**HISTORIC LANDMARKS COMMISSION
DESIGN REVIEW COMMITTEE (DRC) MEETING**

Spiedo Restaurant – Historic Preservation Permit Adjustment to allow a new door, recessed entree way, and replacement of the existing awning with an arched awning, on the side elevation of the Farmer's Union Building located on 151 West Santa Clara Street. The Farmer's Union Building is designated as a City Landmark (City Landmark File No: HL01-139) on the Historic Resources Inventory. Across from San Pedro Street and the proposed location of the door, is the Lamolle Residence which is a Structure of Merit located at 141 West Santa Clara Street (see attached DPR).

Project name: AD09-402 Spiedo Restaurant - 151 W. Santa Clara St., San Jose

Re: **AD09-402 Spiedo Restaurant**

4 Photo Elevation - New Door Elevation
 SHOWING THE APPEARANCE OF THE NEW DOOR IN THE FACADE.

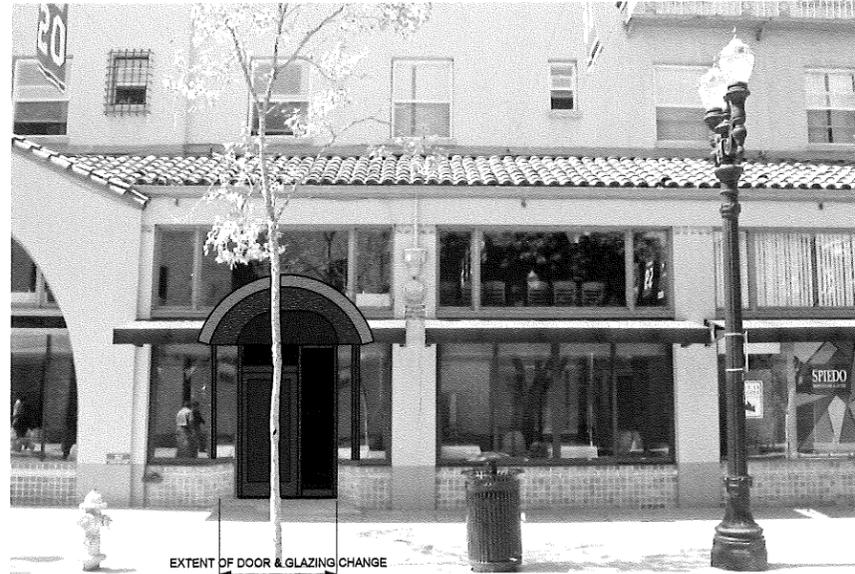
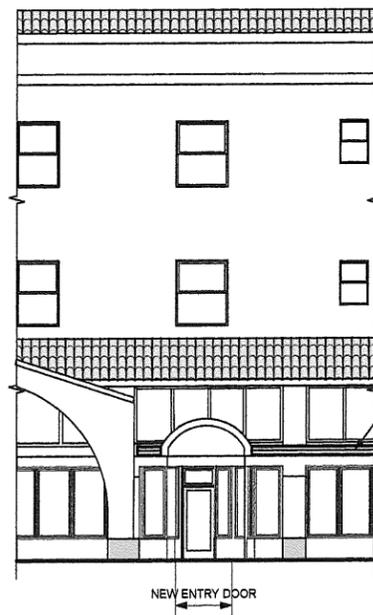
- *Relocating the door to the area within the existing archway.*
- *Creating a diagonal indentation.*
- *Reusing the existing tiles removed for the new entree way.*

- Relocating the door to the area within the existing archway.
- Creating a diagonal indentation.
- Reusing the existing tiles removed for the new entree way.

Relocating the door into the major arch feature of the exterior does not accomplish what the owner is trying to do for several reasons.

1. That location is further away from the direct route from kitchen to outside table service area.
2. The intent to have a minor ingress/ egress is defeated by doing so.
3. The number of inside patron seats that are reduced by this location is larger than the chosen location having some impact on the businesses profitability.

Creating a diagonal indentation. This suggestion is presented in the submitted revised design.

Reusing the existing ceramic tiles. This is being done.

The concept of installing a small, curved awning over the door, was based on a suggestion received about making the doorway part of the arch and awning theme of other entrances to the building along the same street side.

As the architect, I suggest this as a compromise to installing the door in the main arch feature. This accomplishes the minor entrance concept, allows for the main building architecture to be complemented by the awnings, and the distinctive building arches to be expressed as they are now.
